DRAFT MINUTES MHCC MEETING

October 25-27, 2016

MANUFACTURED HOUSING CONSENSUS COMMITTEE (MHCC) MEETING

Figure 2. Installation detail for Example#1 (FFF using crushed stone pad on subgrade)

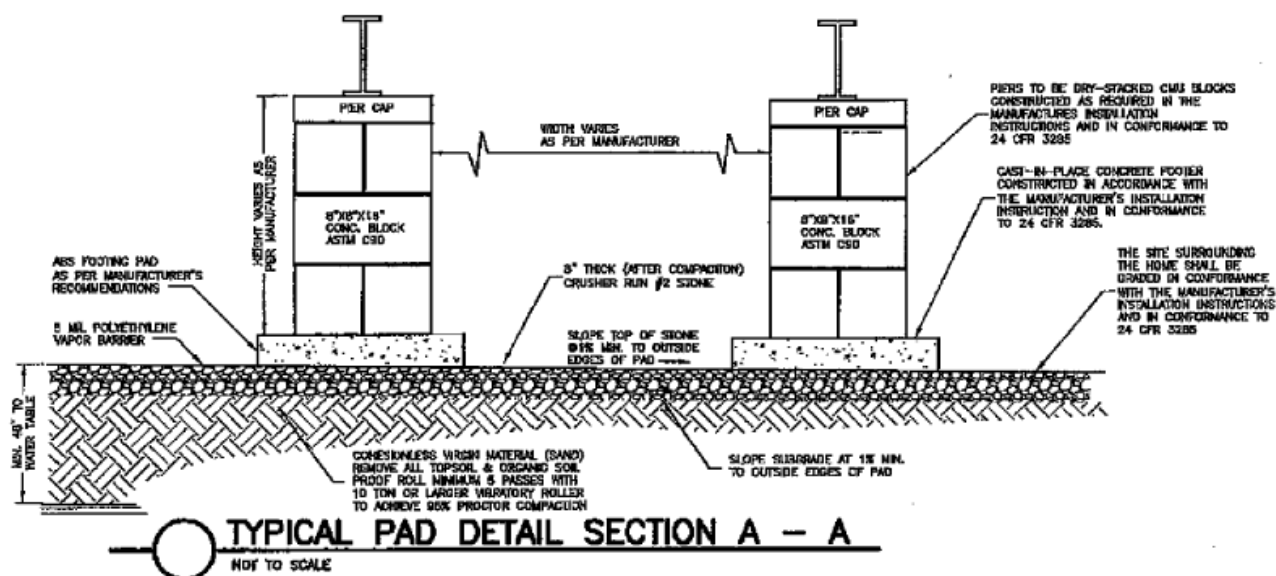
This design represents a reasonable application of the FFF technical requirements in accordance with Section 4.2 of the ASCE 32 standard. For example, it appropriately defines non-frost-susceptible material and requires it to be well-drained and to extend below the required frost depth. However, it places the burden on the local authorities for determining frost-susceptibility for each site application of the design, while at the same time requiring engineering verification (see "DESIGN NOTES" below). The reverse process is more appropriate (i.e., the engineer determines and the authority verifies). This may cause some unintended confusion as to roles and responsibilities which may be entirely missed by installers and those responsible for enforcement. Local authorities have an inspection and verification role, not a construction management or design decision-making role. To do otherwise creates a conflict of interest due to a lack of appropriate separation of roles and responsibilities.

This FFF design also includes a detail (Figure 2) which requires the subgrade to be cohesion less (sand) extending to a minimum depth of 48 inches and compacted with a 10 ton or larger vibratory roller. The water table is required to be at least 48 inches below finish grade together with surface grading required to meet the HUD code. Thus, the detail seems reasonably consistent with the technical intent of the design notes, despite confusion regarding important installation process considerations related to roles and responsibilities as mentioned above. However, the indicated “cohesion less (sand)” subgrade material could be moderately frost susceptible if it is a very fine sand (e.g., approaching silt-size particles). Thus, the Design Notes and plan detail should be clarified that the “6% of mass passing #200 sieve” also applies to the vaguely described cohesion-less sand material in the installation detail.

Figure 3. FFF installation detail for Example #2 (FFF with piers directly on soil) based on SBRA/Hayman (2010) report.

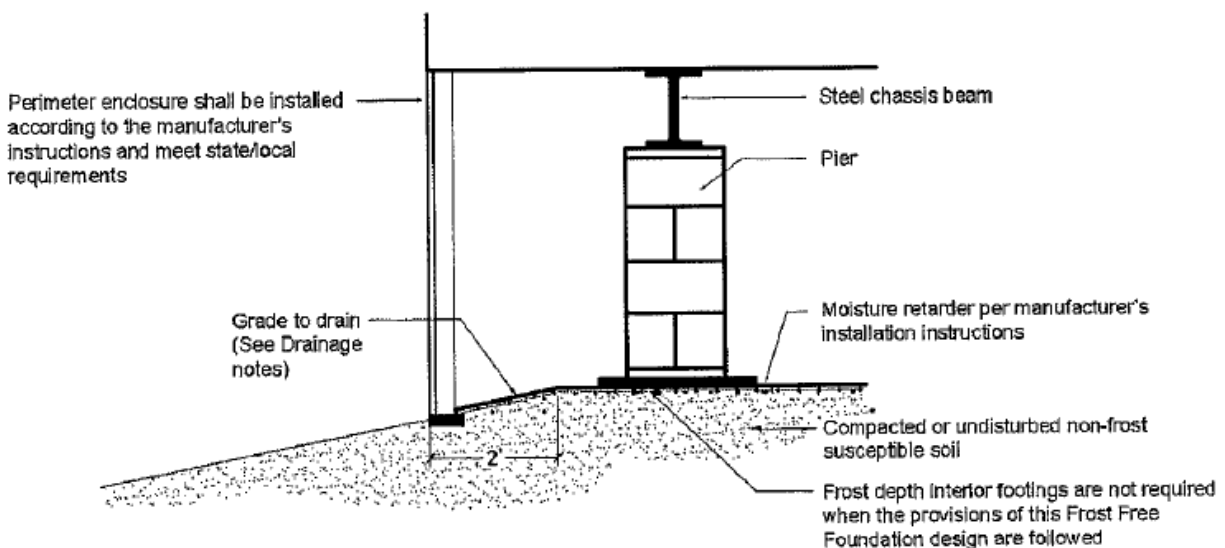
This design has a distinct difference from Example #1 and the ASCE 32 provisions: it relies exclusively on ensuring that “the soil beneath the manufactured home stays dry thereby preventing frost heave.” The report by SBRA/Hayman (2010) mistakenly claims that “Soil type is not relevant using the Frost Free Foundation design. Soil tests are not necessary.” For reasons discussed below, it is the opinion of this author, having served on the ASCE 32 committee and its task group on development of the non-frost-susceptible soil criteria, that these statements are not representative of the intent of the ASCE 32 standard or equivalent alternative procedures for ensuring the intent is met. (Refer to the earlier discussion on the meaning of key terms and clauses in the ASCE 32 standard.)

For example, the installation detail based on the SBRA/Hayman (2010) report reveals the following (see Figure 3):

Figure 4. Installation detail for Example #3 (“Floating Slab” FFF)

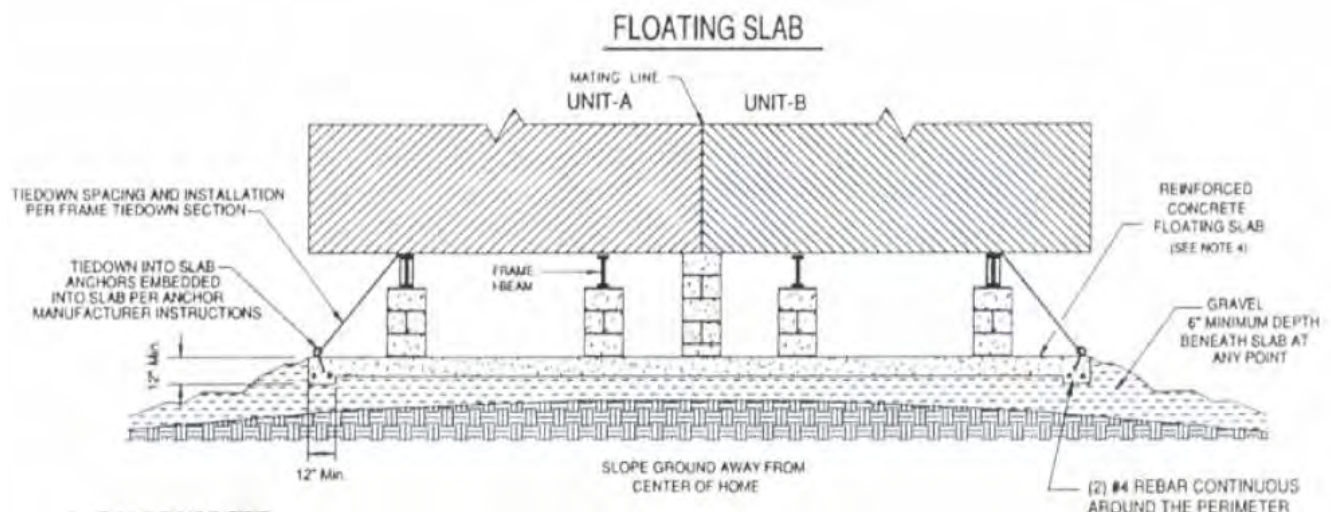
Relevant notes accompanying the installation detail shown in Figure 4 are as follows:

Figure 5. FFF installation detail for Example #4 (Monolithic Slab FFF)

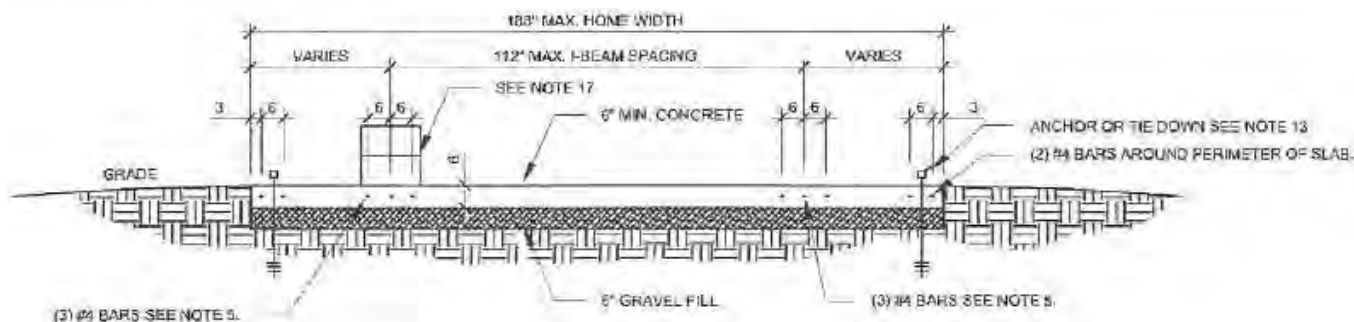
Relevant “GENERAL NOTES” associated with the above installation detail are as follows:
